**Department of Energy**

This is in response to your July 30, 2002 letter, regarding seismic issues related to the construction of the High-Level Waste Facility of the Hanford Waste Treatment Plant (WTP). The Department of Energy (DOE) appreciates the expertise and support provided by the Defense Nuclear Facilities Safety Board.

**ASSUMED PROBABILITY OF TECTONIC ACTIVITY,
AND ADEQUACY OF GROUND MOTION
ATTENUATION MODEL USED IN THE DESIGN OF
THE
WASTE TREATMENT PLANT**

August 26, 2002

Figure 2. Comparison of mean hazard curves from the Yakima Folds at the 200 East Area for original and modified sets of probabilities of activity.

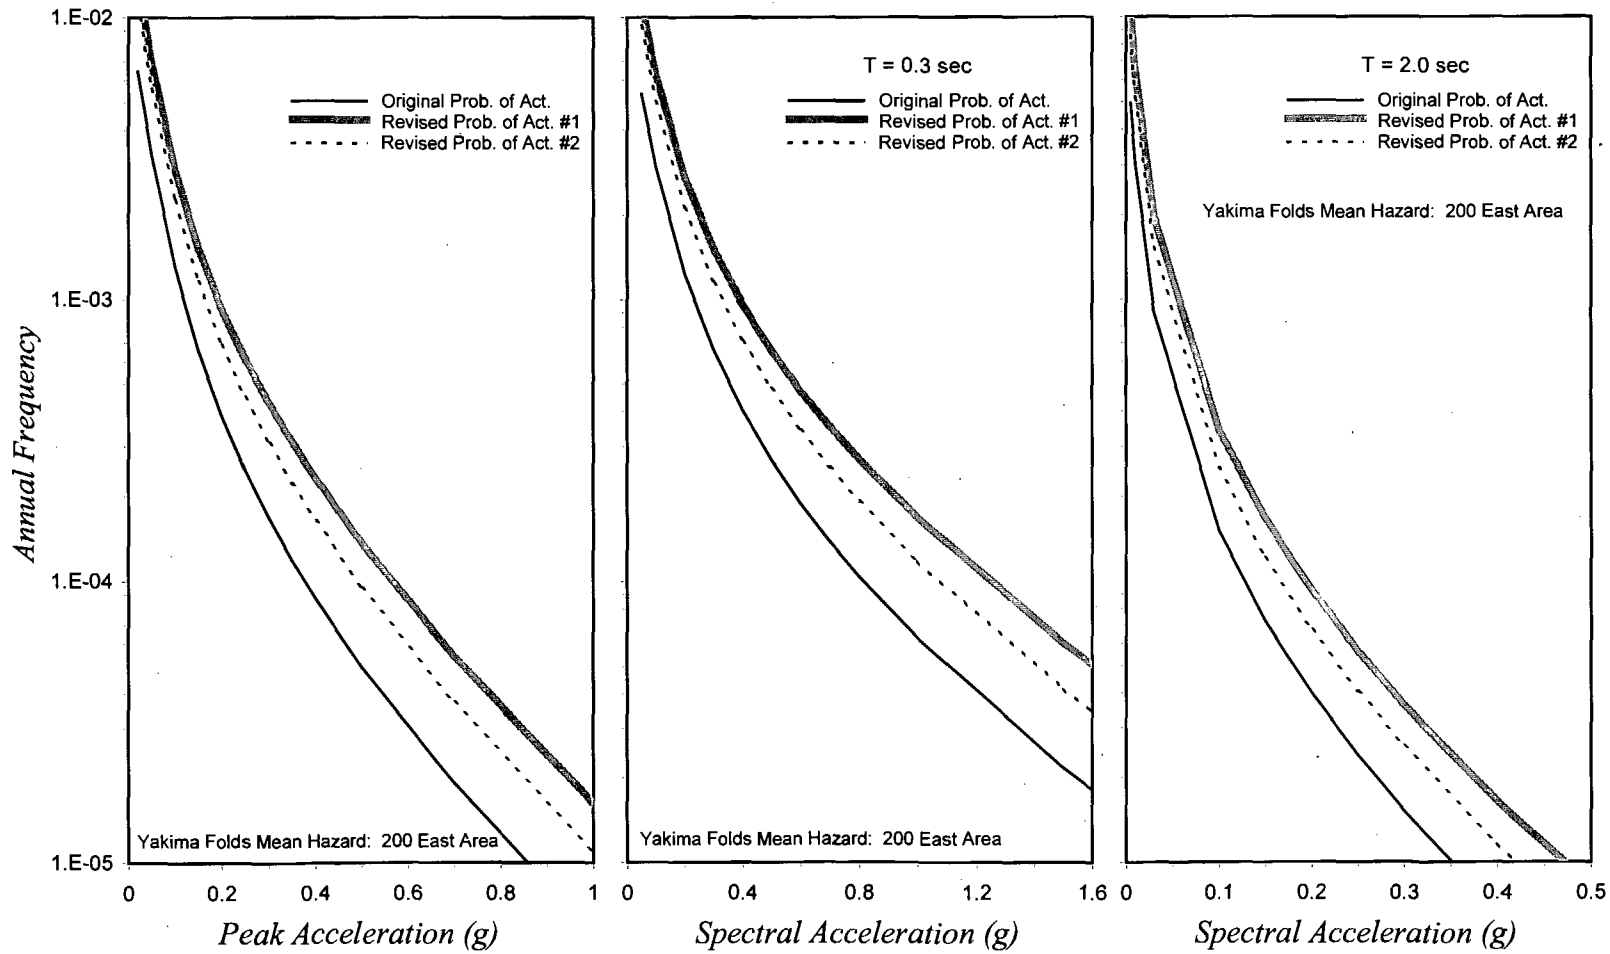
A request was made by the Defense Nuclear Facilities Safety Board staff to perform probabilistic seismic hazard curve sensitivity studies using alternative probability of activity values for the "fault" seismic sources. Table 3 below includes three sets of probabilities of activity for the Yakima Fold seismic sources: the original values used in Geomatrix (1996) and two sets of values used for the sensitivity studies that were proposed by the DNFSB staff.

Figure 2 indicates the change in the composite Yakima Folds hazard curve by comparing the original hazard curve with those using the two sets of modified probabilities of activity. The readily available hazard curves for three spectral ordinates – PGA, 0.3 sec, and 2.0 sec – are indicated.

While these sensitivity studies have been completed, the discussion in Section 4.1 above related to how the probability of activity values were originally developed continues to be valid. DOE's position is that the probability of activity values in the modified sets are inappropriate for use in the probabilistic seismic hazard analysis for the WTP.

Figure 3. Comparison of Total Mean Hazard Curves at the 200 East Area for Original and Modified Sets of Probabilities of Activity.

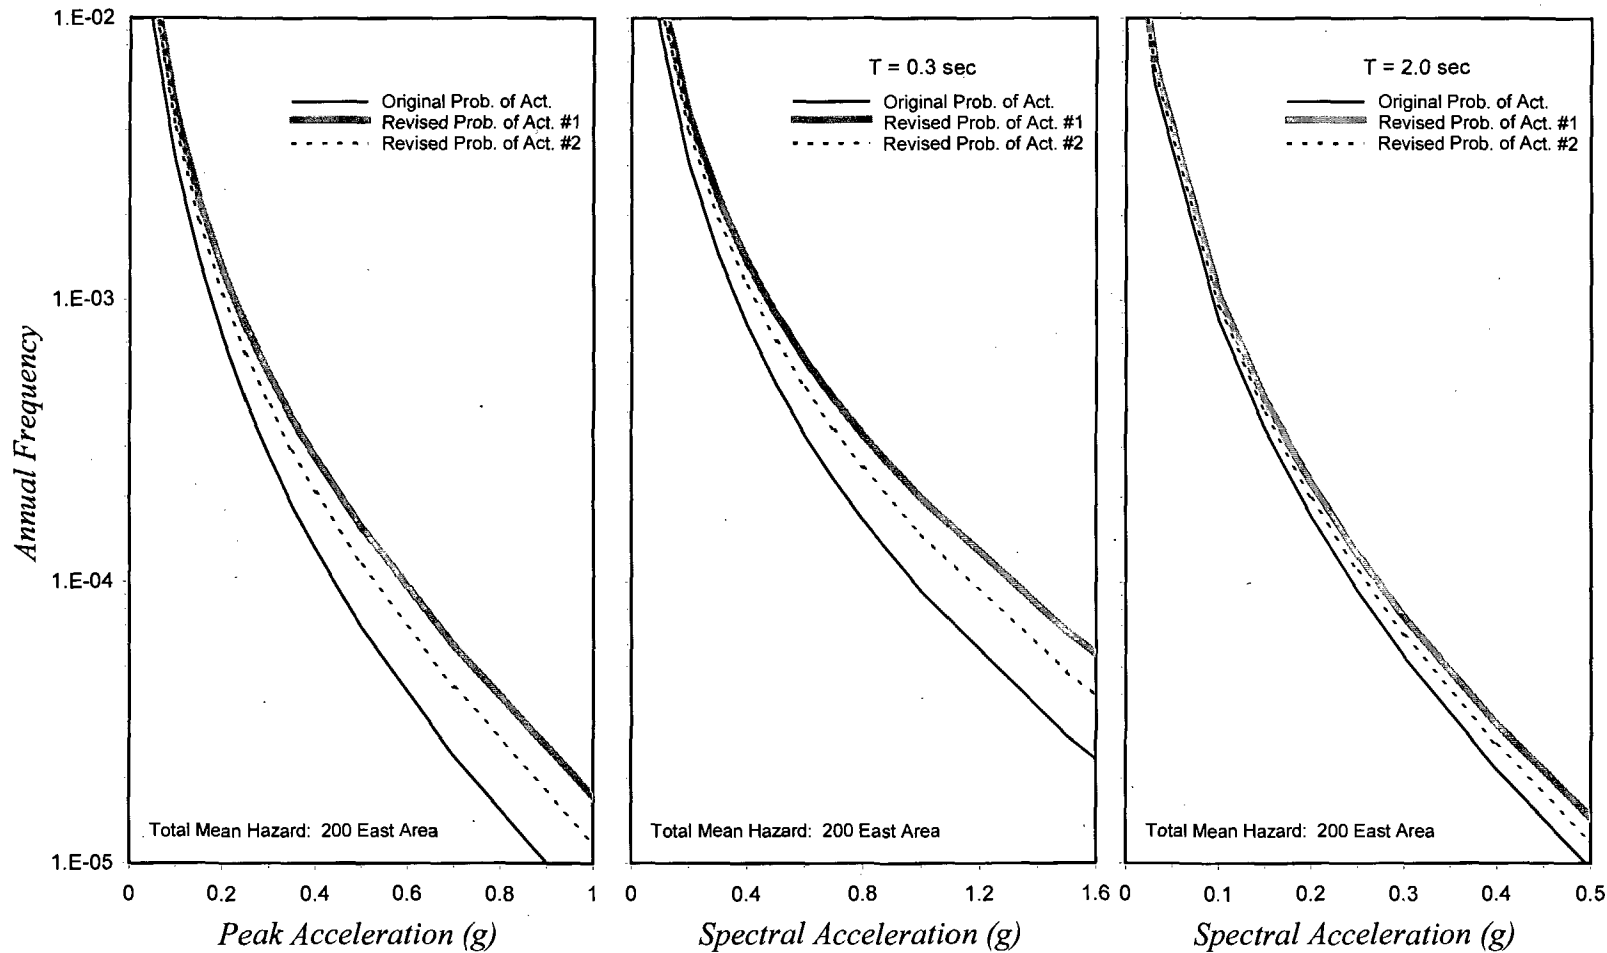
Figure 3 is similar to Figure 2, except the total hazard curves are presented.

Figure 8. Influence of Assumed Sigma Profile.

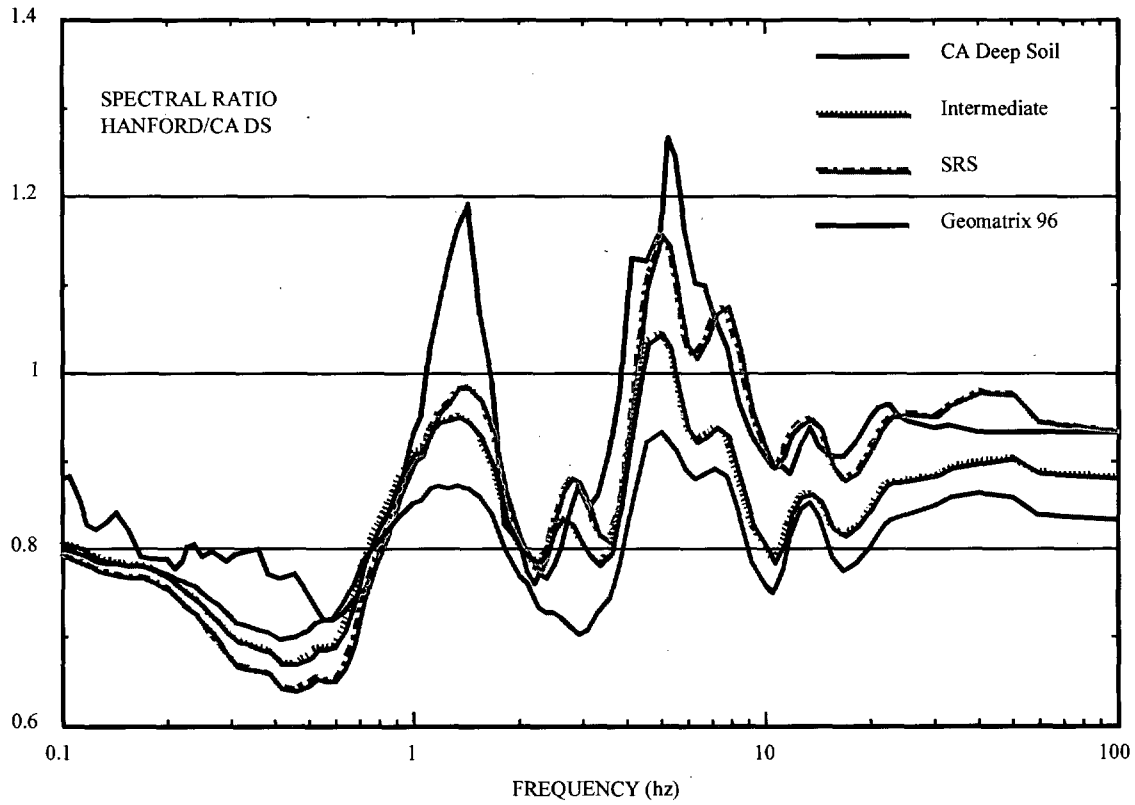
To determine sensitivity of the relative amplification ratio, Hanford to California deep soil, to the σ profiles, three sets of randomized convolution calculations were performed. The first set used the values of σ associated with the California deep soil profile, a second set using the SRS σ profile and a third set using an intermediate σ profile (average of California deep soil and SRS) for the Hanford P1 profile. A plot of these σ profiles is shown in Figure 7. The results from these calculations are presented in Figure 8 together with the data originally presented in Geomatrix 1996.

If the relatively large values of sigma associated with the California deep soil data set are used, the relative amplifications are uniformly less than unity across the entire frequency range of interest. If the small values of sigma associated with the SRS data set are used, the relative amplifications are also less than unity, except in the frequency range from 4 Hz to 9 Hz. The exceedances are generally small with the maximum exceedance being approximately 15% at about 5 Hz. If the intermediate range of sigma values is used, exceedances occur in the narrow frequency range from 4 Hz to 5 Hz with the maximum exceedance being only 3%. These exceedances are less than those originally contained in Geomatrix 1996. The conclusion of this sensitivity study is that the relative amplification is less than unity over almost the entire frequency range of interest, with only small exceedance over a very small frequency range. These exceedances are insignificant when compared to the other uncertainties typically included in the assessment of the design basis hazard.

Figure 21. Statistics of Spectra Ratios for Hanford P1 Profile (California soil velocity correlation model, 200 East Area soil curves) Divided by California Deep Soil.

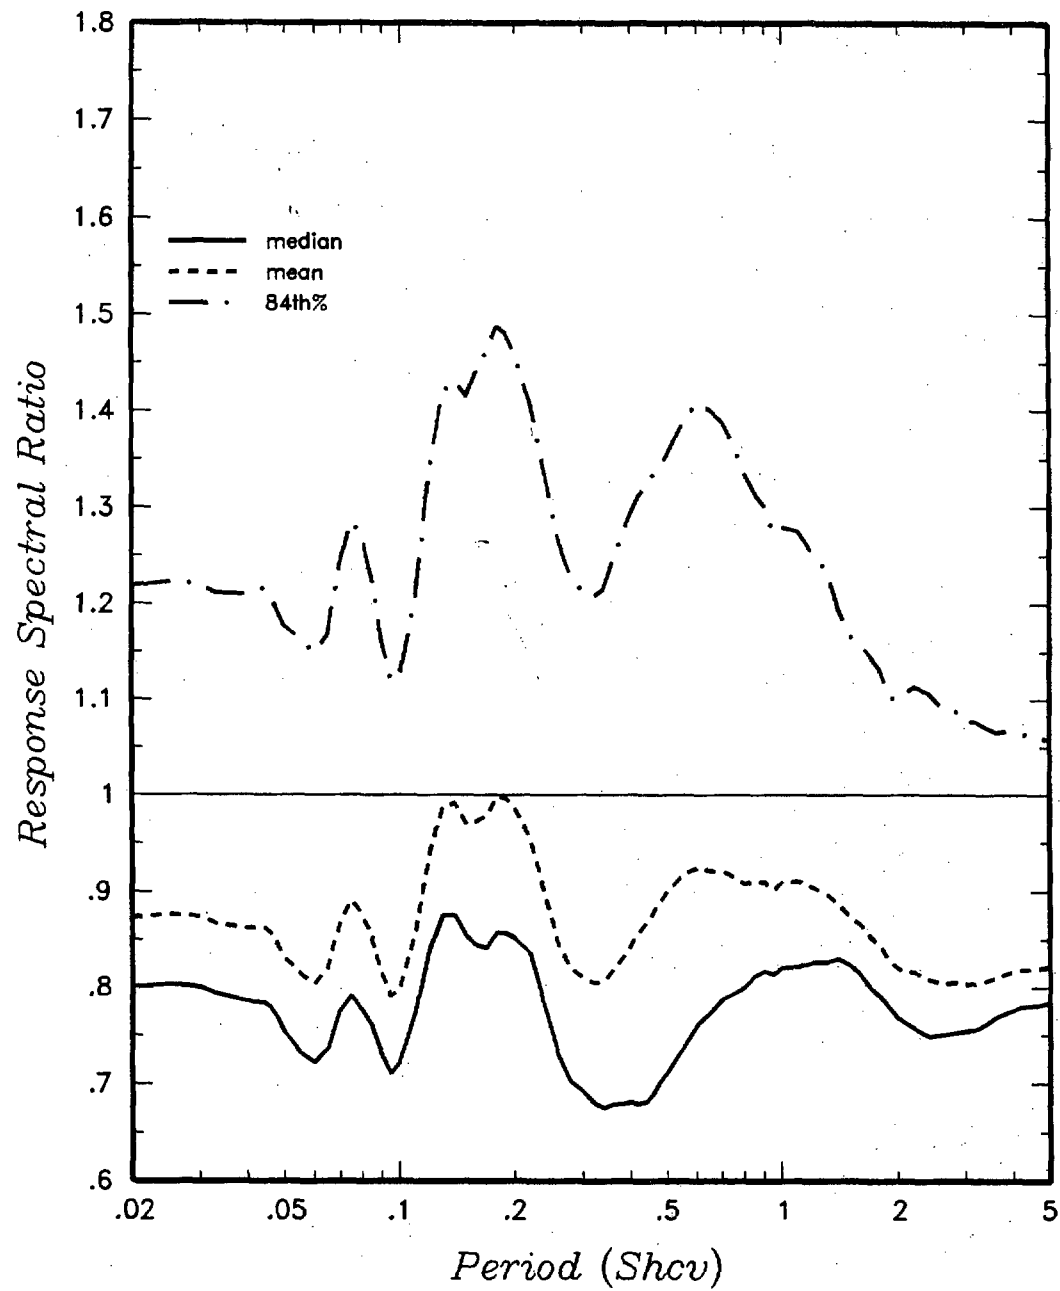
This attachment provides an updated relative site response analysis comparing the response of the Hanford profiles to that of California soil sites representative of empirical California soil attenuation models. This updated analysis incorporates randomization of the California and Hanford profiles. The analysis steps agreed upon in informal discussions with cognizant DNFSB staff are numbered below.

Figure 21 shows the statistics of the ratio for the Hanford P1 profile response divided by the California soil site response. Shown are the median (mean log), mean, and 84th-percentile (lognormal assumption) spectral ratios.
